CLEARFIELD CITY PLANNING COMMISSION MEETING AGENDA

2. Discussion and Possible Action on **SP 2025-0901**, a site plan request by Fusion-AE to construct a Quick Quack carwash at the subject location. **Location:** 777 East 700 South (TINs: 12-004-0184, 12-004-0032, 12-004-0188, 12-004-0031, & 12-004-0030). **Project Area:** 1.07 Acres. **Zone:** C-C (Gateway Corridor Commerce). **(Administrative Matter).**

SUBJECT: Discussion and Possible Action on **SP 2025-0901**, a site plan request by Fusion-AE to construct a Quick Quack carwash at the subject location. **Location:** 777 East 700 South (TINs: 12-004-0184, 12-004-0032, 12-004-0188, 12-004-0031, & 12-004-0030). **Project Area:** 1.07 Acres **Zone:** C-C (Gateway Corridor Commerce) **(Administrative Action).**

QUICK QUACK CLEARFIELD 700 SOUTH
SITE PLAN
777 EAST 700 SOUTH CLEARFIELD, UT 84015

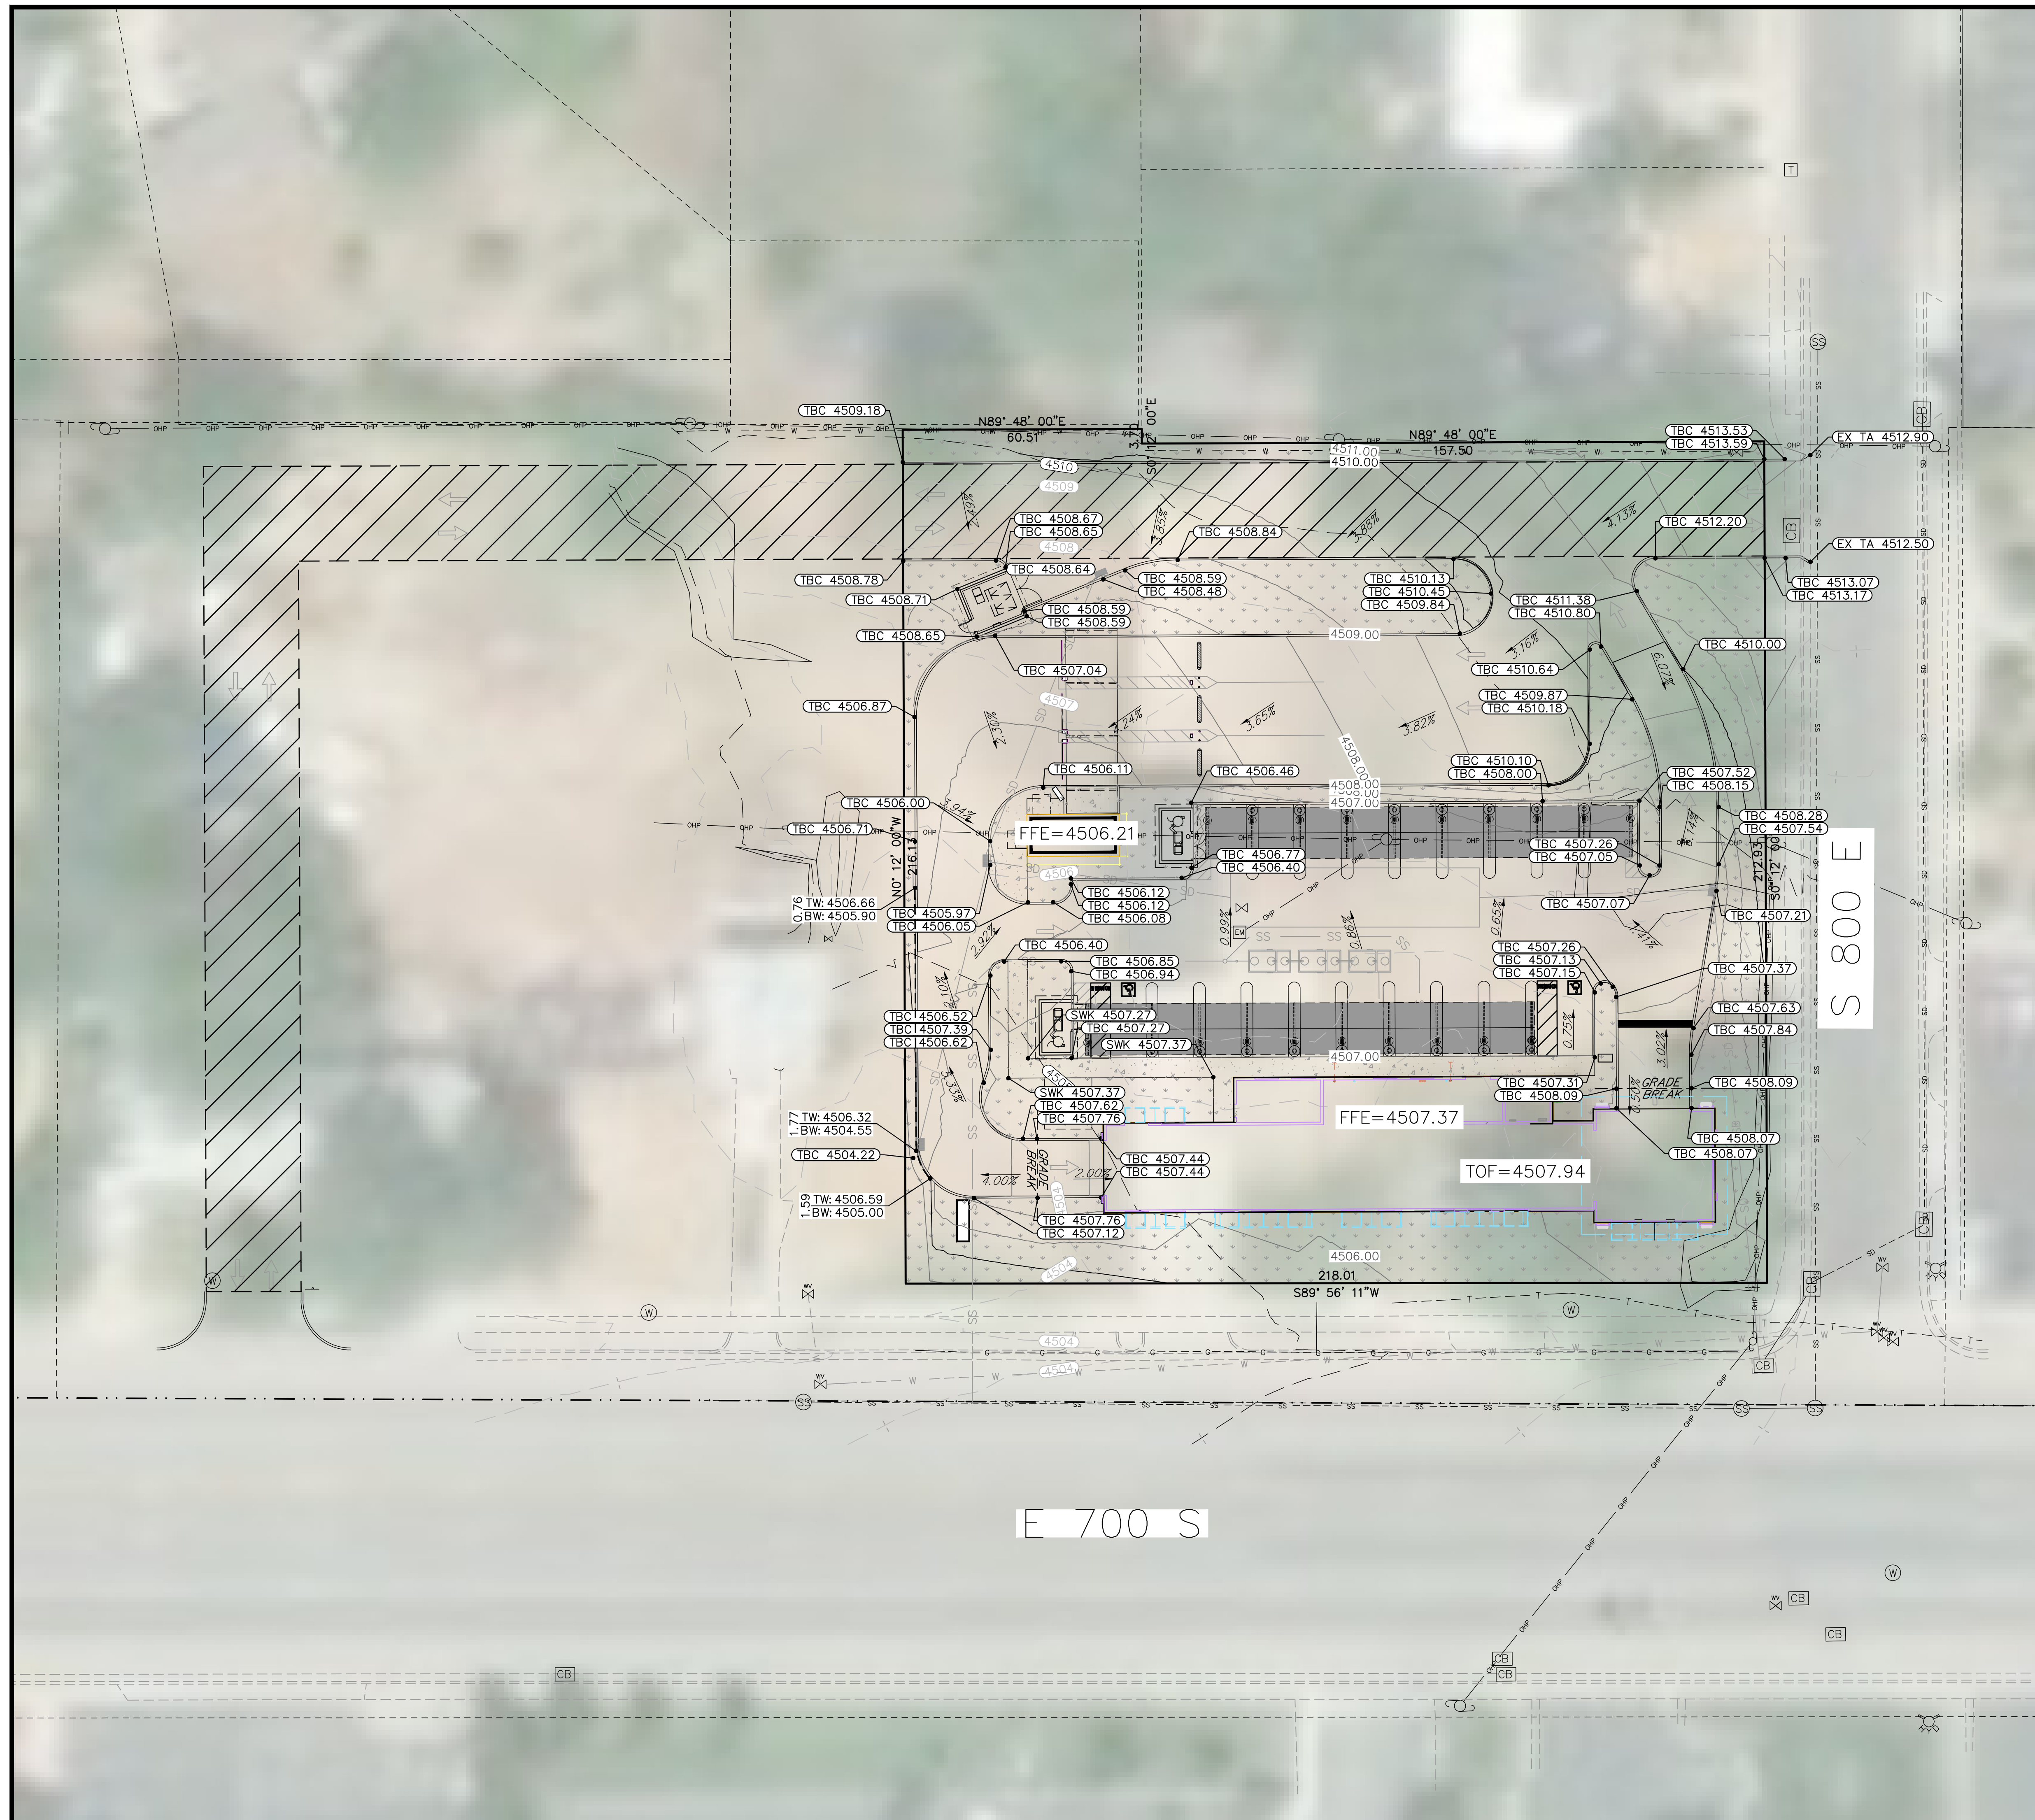
- 1) The interior sidewalk shown on the plans will need to connect into the public sidewalk network.
- 2) The project shall receive UDOT (Utah Department of Transportation) approval for any work required within the UDOT right-of-way.

- 3) The plans shall be revised to provide the required streetscape improvements along 700 South which includes:
 - a. A minimum eight-foot (8') planted street buffer with street trees spaced appropriately based on size as outlined in Section 5.6.6 of the FBC;

- b. A minimum six-foot (6') wide clear sidewalk; and
 - c. Double acorn streetlights spaced appropriately as outlined in Section 5.6.5 of the FBC.
- 4) Windows shall be added to the South façade so that no horizontal segment of the street facing façade is windowless for more than fifteen (15) feet.

- 9) A snow stacking area shall be added to the plans as outlined in the staff report.
- 10) The plans shall be revised to address Engineering requirements as outlined in the review letter dated September 16, 2025.

L-1

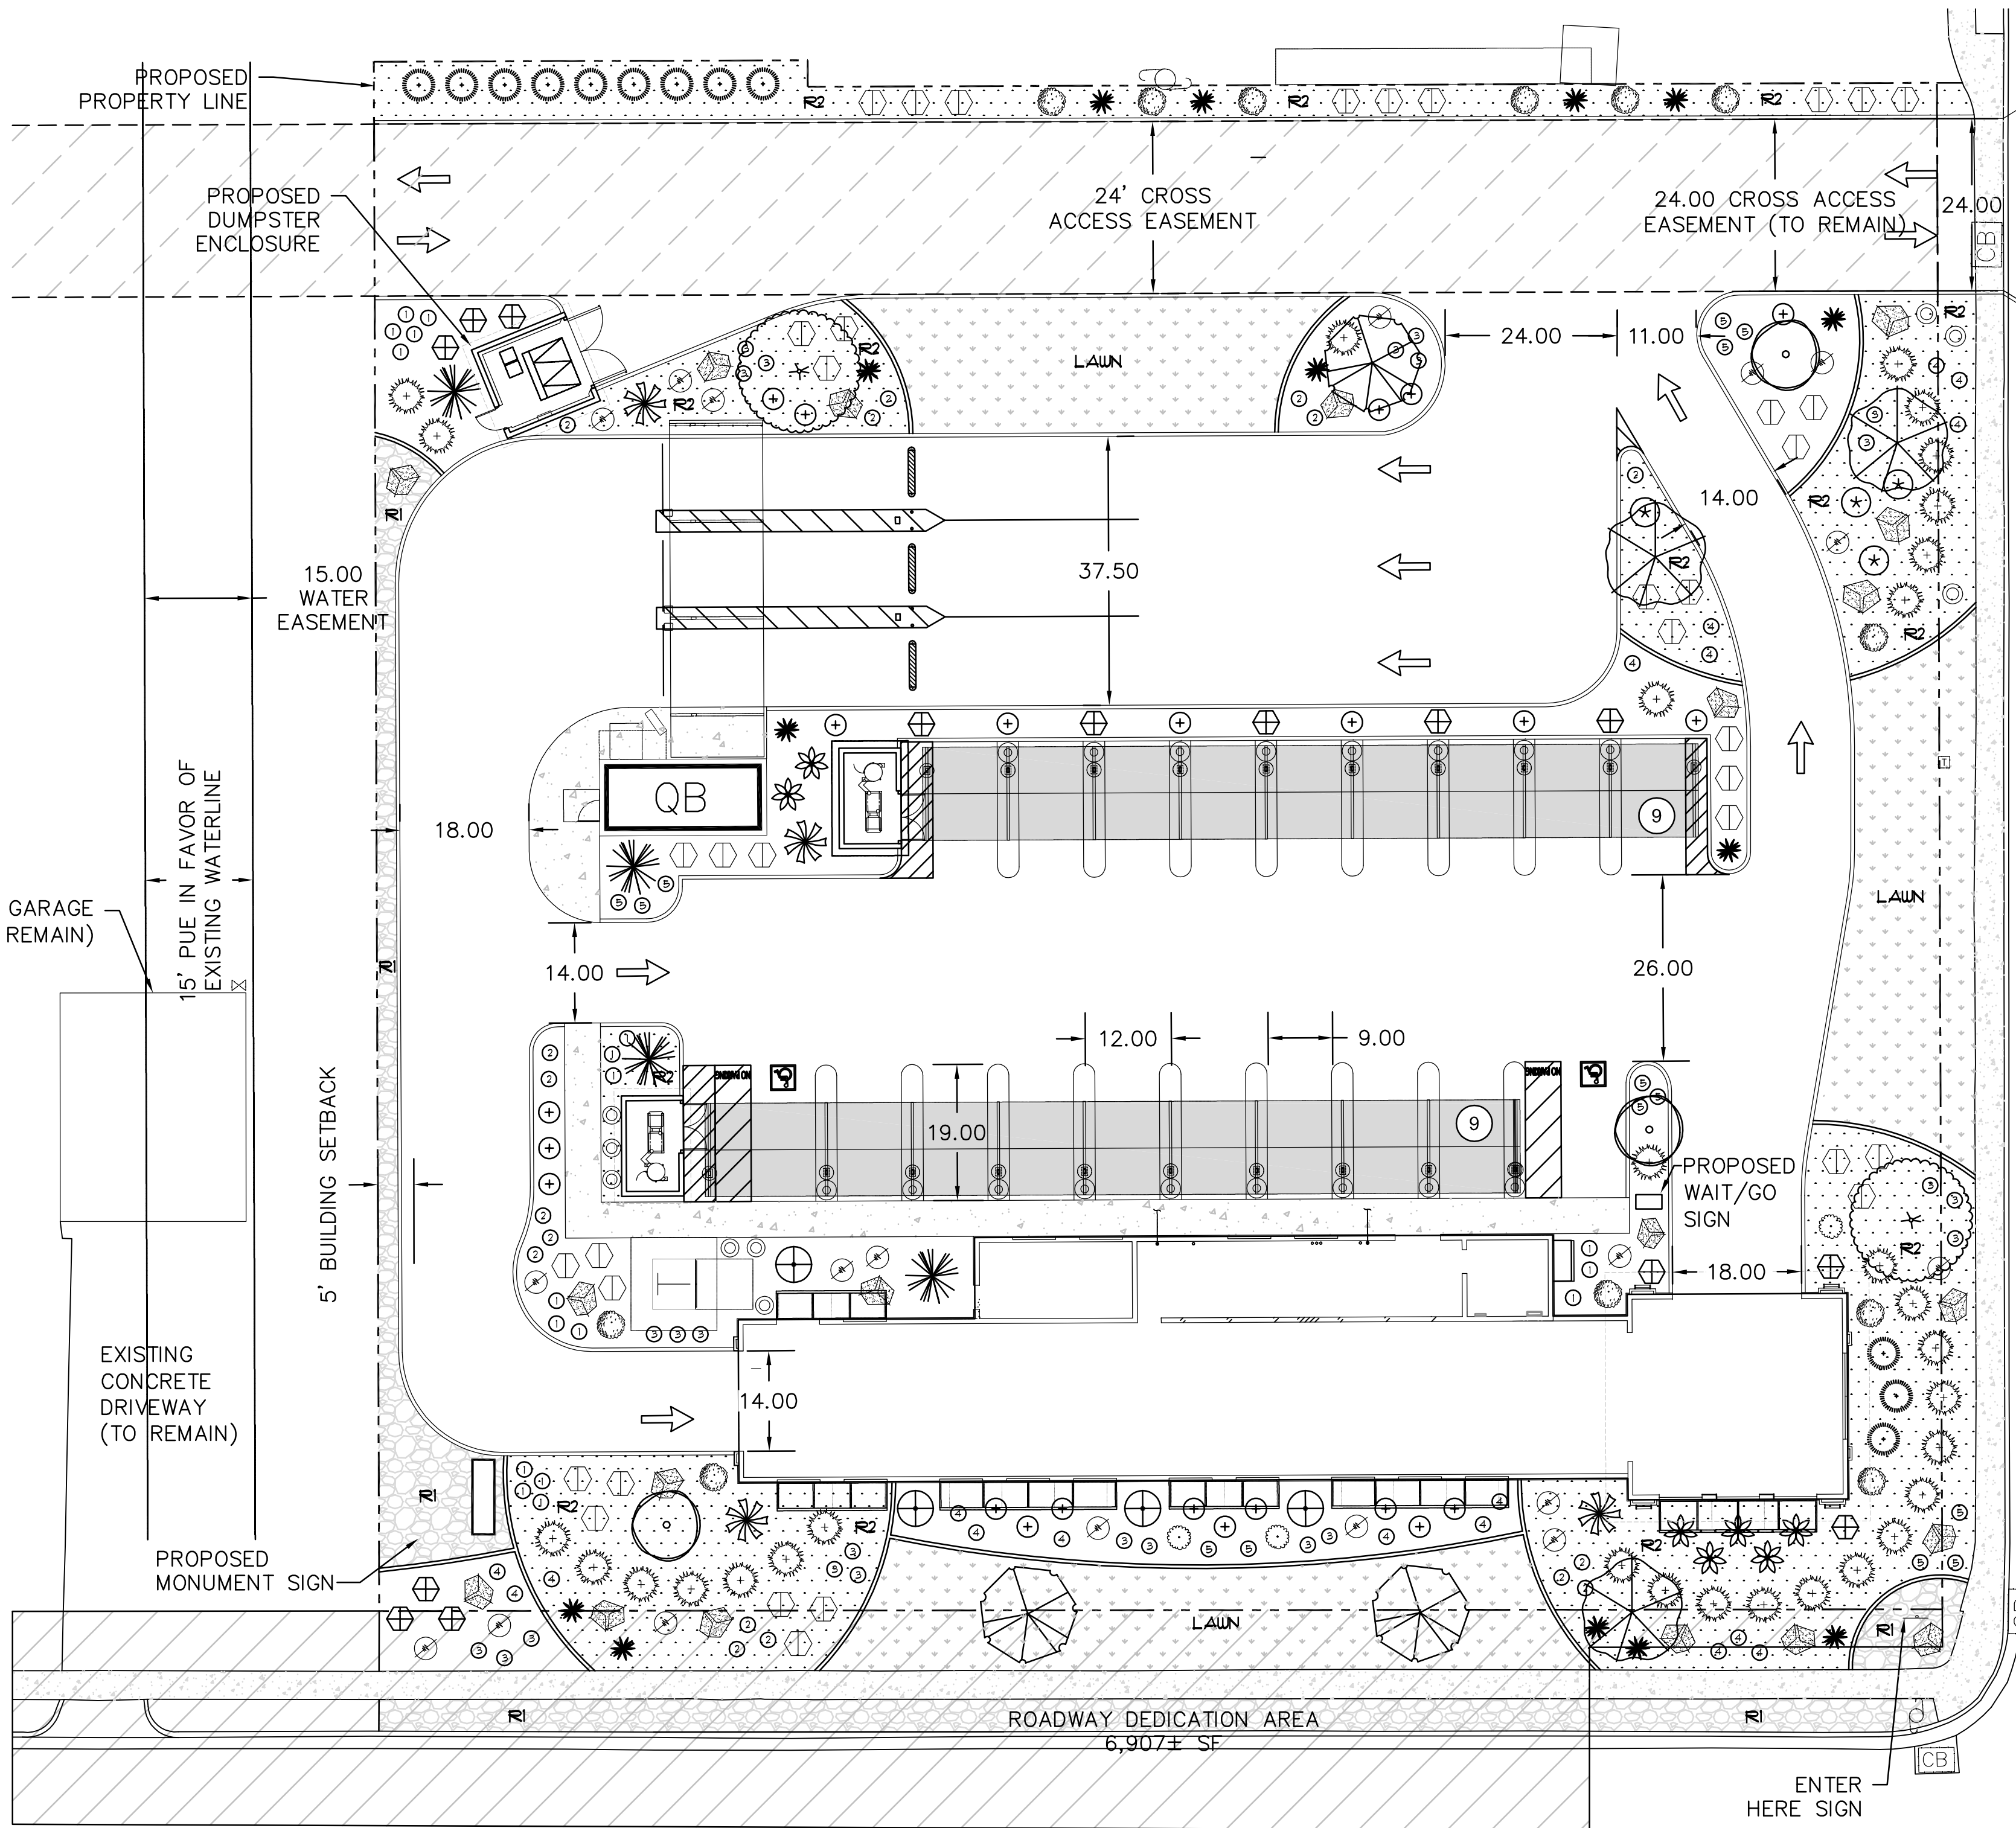
Staff Note: Proposed turf grass is approximately 28% of the landscaped area. The plans will need to be revised to comply with the 15% maximum.
<i>Plant material shall be placed around the perimeter of the building footprint in a 5 foot minimum planting strip with the exception of entrances, utilities, and where required setbacks are less than 5 feet. For setbacks less than 5 feet, plant materials shall be placed around the perimeter of the building footprint in a planting strip the dimension of the setback, unless no setback exists.</i>	Complies with FBC. Staff Note: Landscaping surrounds the perimeter of the building except where the building protrudes near the vacuuming spaces on the rear.
<i>Plant Selection:</i> Plants must be water wise. Plants may be selected from the State of Utah waterwise plant list at https://waterwiseplants.utah.gov or the Conservation Garden Park database at https://conservationgardenpark.org/plants .	Complies with FBC.

- 6) The landscape plans shall include the following revisions:
 - a. At least twenty-one (21) trees shall be provided to meet the minimum requirement. The street trees required do not count toward meeting this standard.

- b. The proposed turf grass shall be revised to comply with the maximum allowed amount of 15% of the total landscaped area.
 - c. The plan needs to be revised to meet the specific shade tree and hedge requirements for District Transition Buffers as found in section 7.3 of the FBC.

- d. A fence that meets the District Transition Buffer requirements of section 7.3 of the FBC needs to be added to the plans.
- 7) A fee-in-lieu of civic open space shall be paid to Clearfield City in the amount of \$46,590.00 as required by Section 8.2.3 (3) of the FBC for the creation or enhancement of civic open space or streetscape enhancements within the Downtown Clearfield area. This fee will be payable at the time of a building permit.
